CITY OF MORGAN HILL

ADDENDUM NO. 4

DATE: AUGUST 23, 2024
TO: ALL PLANHOLDERS OF THE BUTTERFIELD PARK – PHASE 1 PROJECT
FROM: MARIA ANGELES – PROJECT ENGINEER
RE: QUESTIONS AND RESPONSES

EXAMPLE PAD PREPARATION PLAN

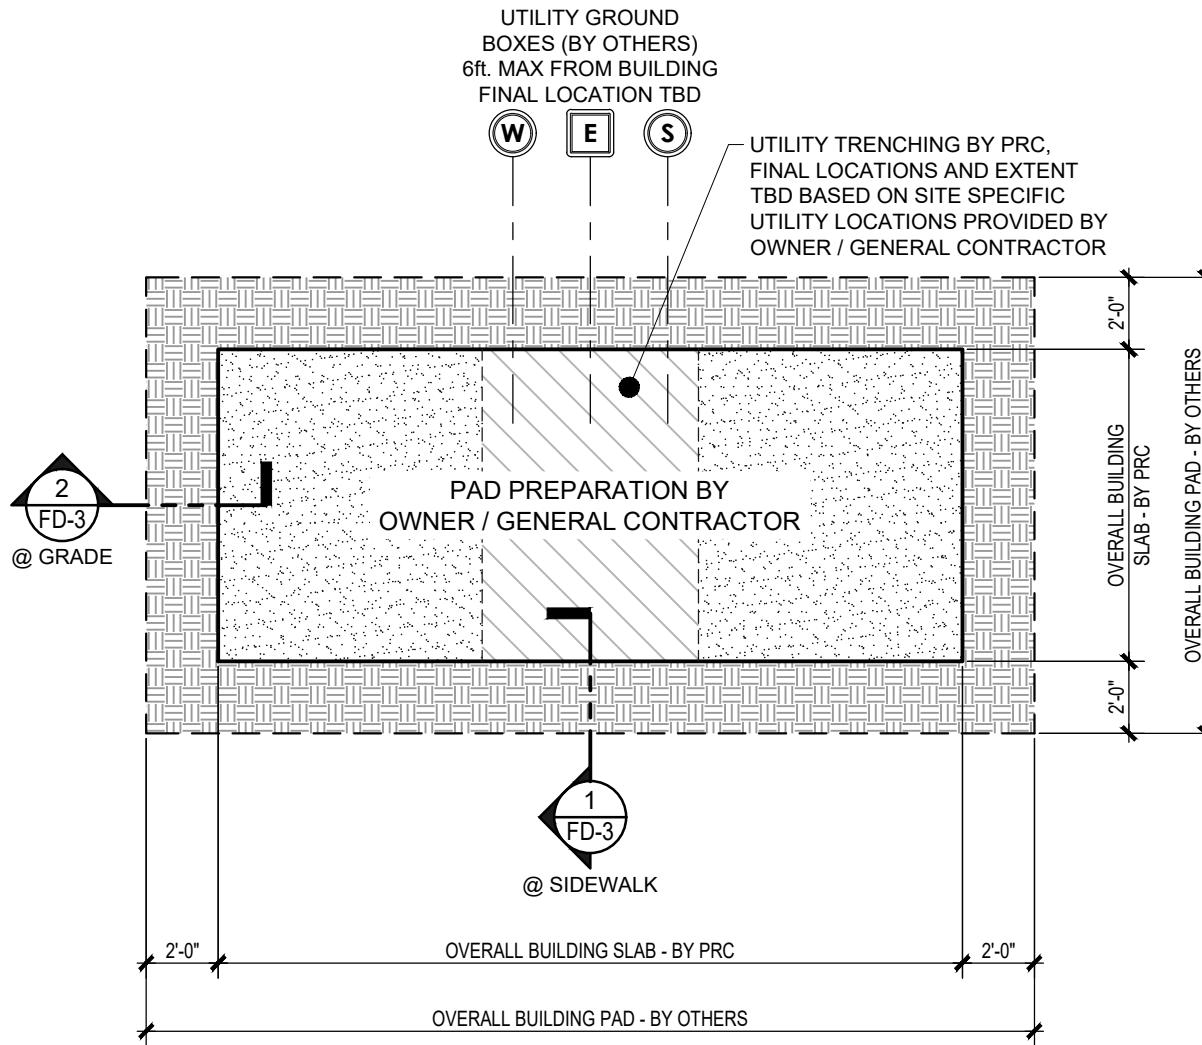
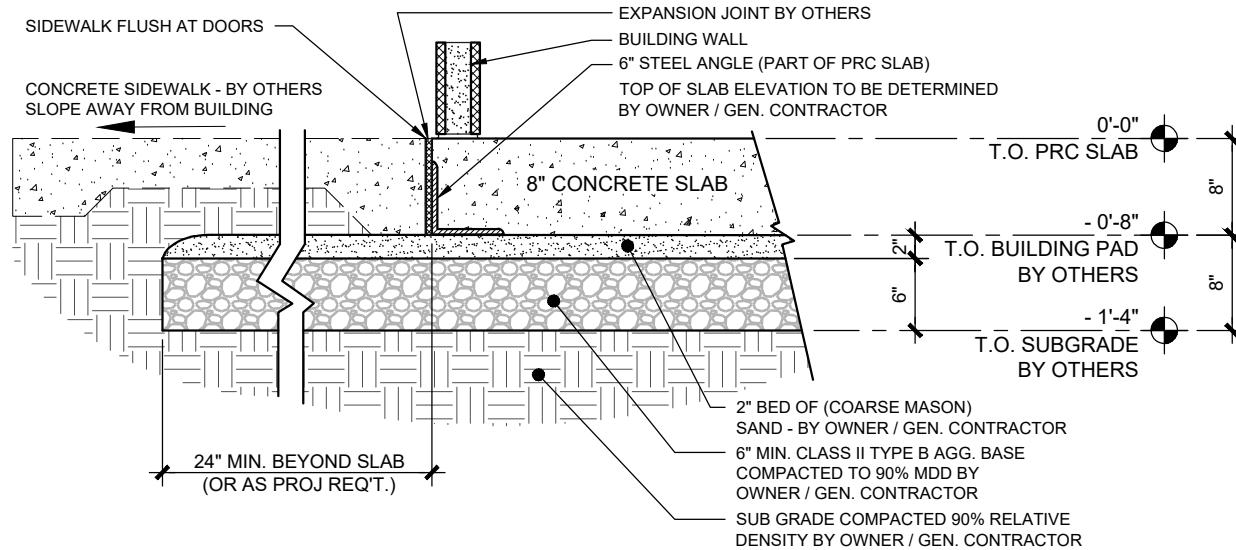
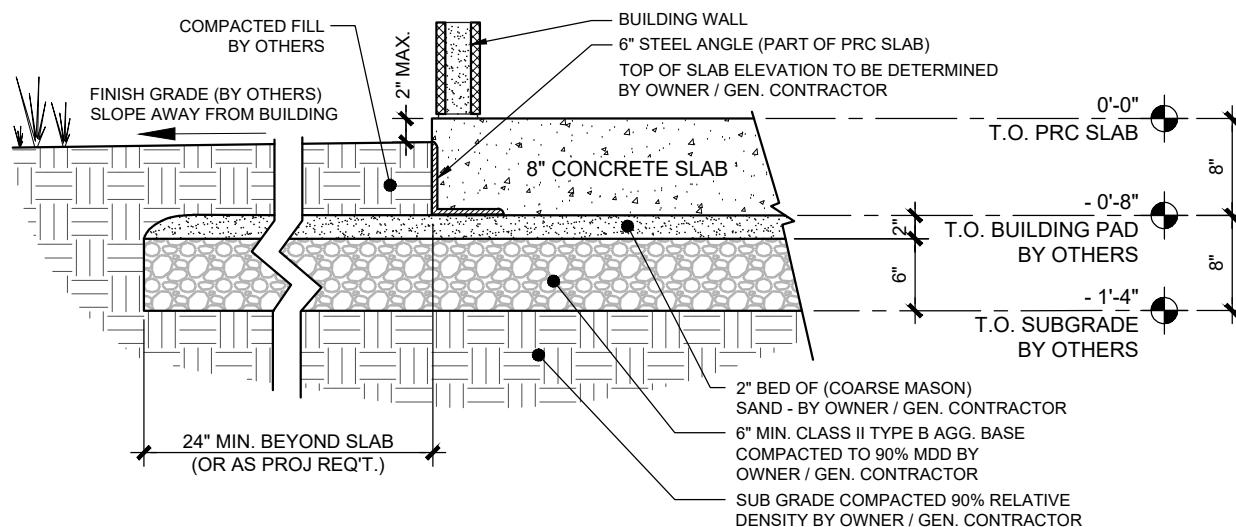
26. Question #30 to City: Please provide the design intent for the surface underneath the Public Restroom Building.

City's Response to Question #30: Please refer to the attached Pad Preparation Plan with additional information.
